J. H. FLETCHER & CO. Box 2187 – Huntington, WV 25722-2187 – 304/525-7811 – FAX 304/525-4025

INFORMATION BULLETIN NO. 114

SUBJECT: **DAMAGE TO TWO-LEG HINGED CANOPY**

ATTACHMENT 1

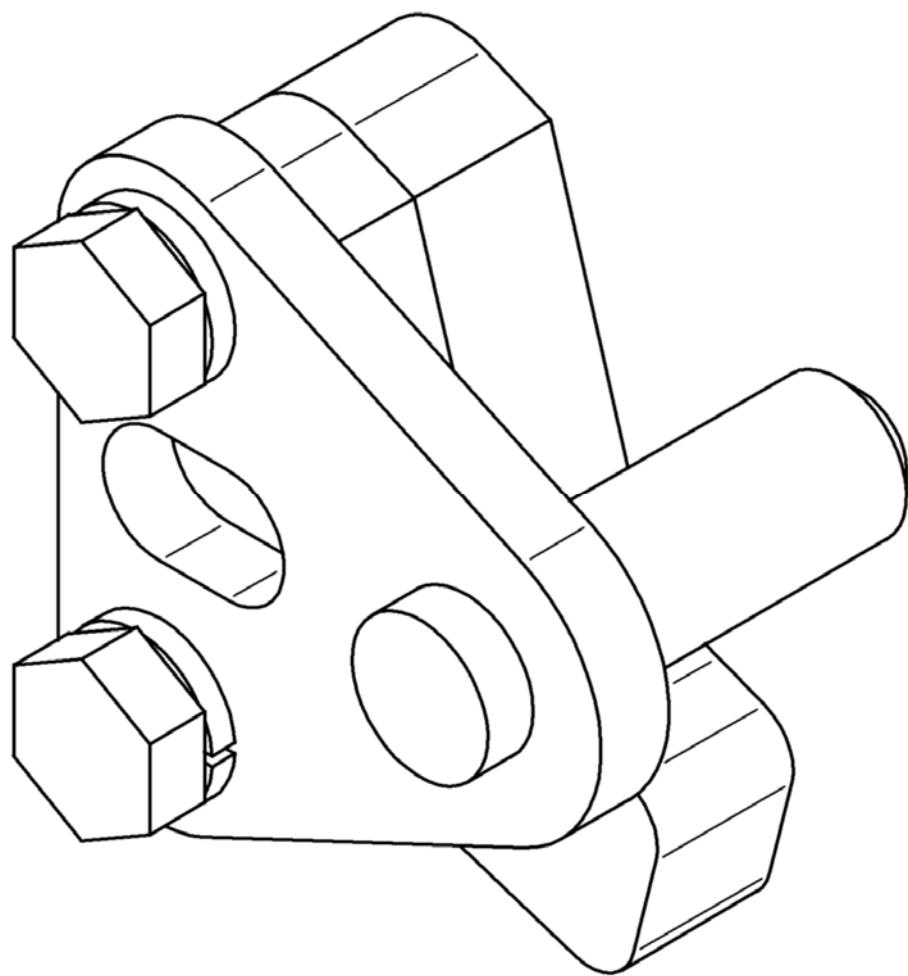
In November 2009 an accident occurred at a West Virginia mine. The information obtained by J.H. Fletcher & Co. ("Fletcher") indicates that the roof bolter operator ribbed the tram canopy while trammimg the roof bolter. The operator steered the machine into the rib. The damage to the tram canopy cylinder was so severe that the cylinder eye separated from the cylinder rod (Attachment 1). When this event took place the cylinder was no longer connected to the tram canopy and the canopy fell on the operator's head. The bolter had tram canopy extensions installed.

CYLINDER EYE

CYLINDER SEPARATED FROM EYE
